Form 3160-5
(June 2019)UNITED STATES
DEPARTMENT OF THE INTERIOR
BUREAU OF LAND MANAGEMENTFORM APPROVED
OMB No. 1004-0137
Expires: October 31, 2021**SUNDRY NOTICES AND REPORTS ON WELLS**
Do not use this form for proposals to drill or to re-enter an abandoned well. Use Form 3160-3 (APD) for such proposals.

8. Well Name and No. DILLON 31 FED COM/401H

EOG respectfully requests an amendment to our approved APD for this well to reflect the following changes:

**Dillon 31 Fed Com 306H****Revised Permit Information 07/18/2022:**

WELL LOCATION AND ACREAGE DEDICATION PLAT

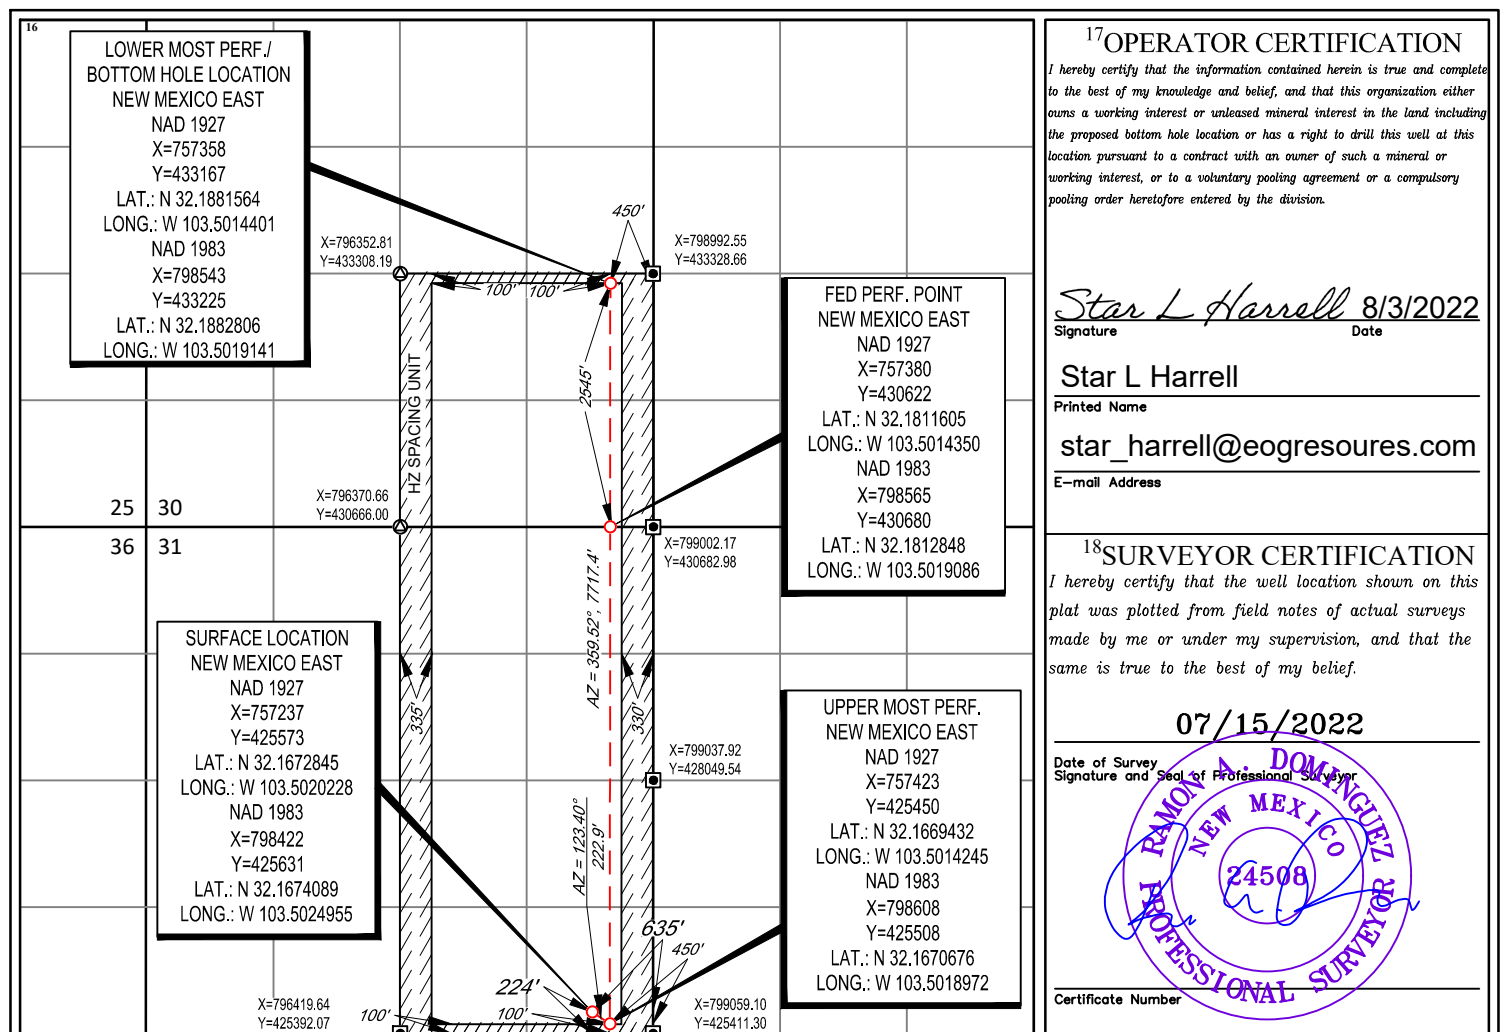
Change name from 401H to Dillon 31 Fed Com 306H.

Change BHL from T-24-S, R-34-E, Sec 30, 2545' FSL, 660' FEL, Lea Co., NM, to T-24-S, R-34-E, Sec 30, 2545' FSL, 450' FEL, Lea Co., N.M.

UL or lot no.	Section	Township	Range	Lot Idn	Feet from the	North/South line	Feet from the	East/West line	County
I	30	24-S	34-E	-	2545'	SOUTH	450'	EAST	LEA
